TEHAMA COUNTY – DEPARTMENT OF PUBLIC WORKS
CONTRACT CHANGE ORDER MEMORANDUM

TO: Jon McClain			FILE E.A	Tehama County 99W & South Main Street Project County Project Number: 2708181 Federal Aid Project RPSTPL 5908(100) Caltrans Contract Number: 02-IJ6204
FROM: James Smolenski				
CCO NO. Eleven 11	SUPPLEMENT NO.	CATEGORY CODE:	CONTINGENCY BALANCE (Including this change): Caltrans \$758,399.74 / City \$522,698.36 / County \$619,629.72	
\$43,000.00		INCR <u> X </u> DECR	HEADQUARTERS APPROVAL REQUIRED? YES NO <u> X </u>	
SUPPLEMENTAL FUNDS PROVIDED \$ 0			IS THIS REQUEST IN ACCORDANCE WITH ENVIRONMENTAL DOCUMENTS? YES <u> X </u> NO

<table border="1" style="width: 100%; border-collapse: collapse;"> <tr><td style="font-size: 8px;">DATE</td><td style="font-size: 8px;">DRAWN BY</td><td style="font-size: 8px;">CHECKED BY</td><td style="font-size: 8px;">DATE</td></tr> <tr><td style="font-size: 8px;"> </td><td style="font-size: 8px;"> </td><td style="font-size: 8px;"> </td><td style="font-size: 8px;"> </td></tr> <tr><td style="font-size: 8px;"> </td><td style="font-size: 8px;"> </td><td style="font-size: 8px;"> </td><td style="font-size: 8px;"> </td></tr> <tr><td style="font-size: 8px;"> </t

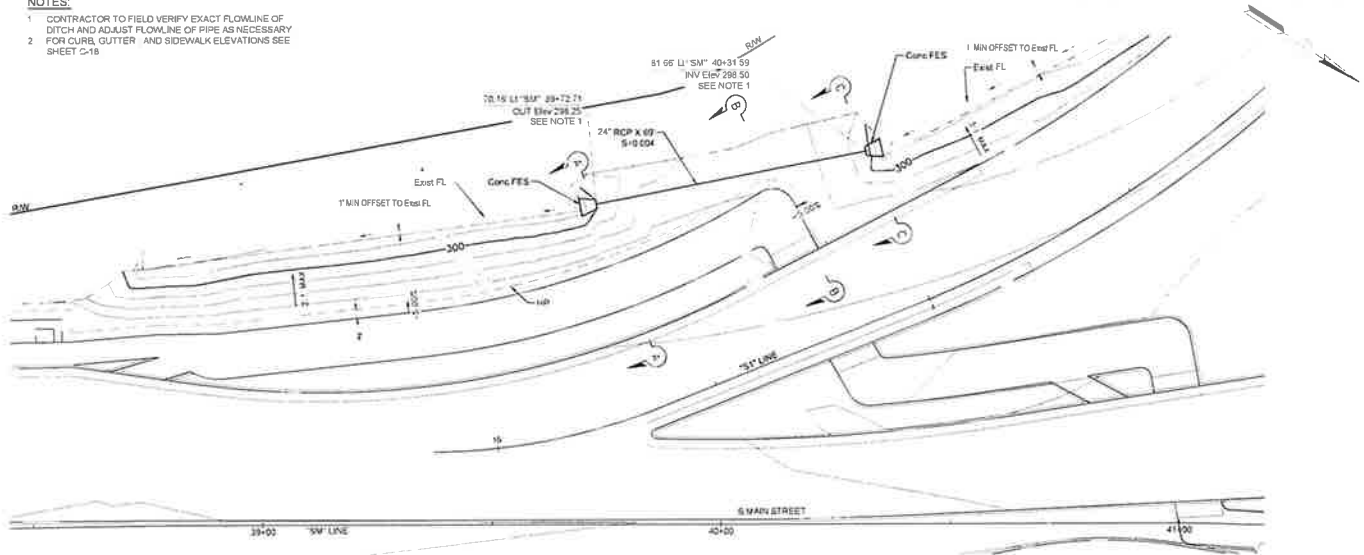
At Location 4, install the added drainage system at “SM” station 39+71 to 40+32 and embankment according to the RFI #31 Additional Info Exhibit 1 sheet attached as Sheet No. 2 of this change.

The plans show to construct new sidewalk from “SM” station 40+23 TO 39+00. However, there is insufficient embankment width available to construct the planned sidewalk section without encroaching into the flowline of the adjacent roadside ditch. In response to the Contractor’s RFI No. #31 and additional original ground topo information, the Designer included the addition of 60 LF of 24" RCP and 2 additional concrete flared end sections.

Item 64 24" REINFORCED CONCRETE PIPE **60.0 LF** (+300%) @ \$600/LF = **\$36,000.00** (+300.00%)
 Item 65 18" CONCRETE FLARED END SECTION **2 EA** (+200%) @ \$3,500/EA = **\$7,000.00** (+200.00%)

- 1 CONTRACTOR TO FIELD VERIFY EXACT FLOWLINE OF DITCH AND ADJUST FLOWLINE OF PIPE AS NECESSARY
- 2 FOR CURB, GUTTER AND SIDEWALK ELEVATIONS SEE SHEET C-18
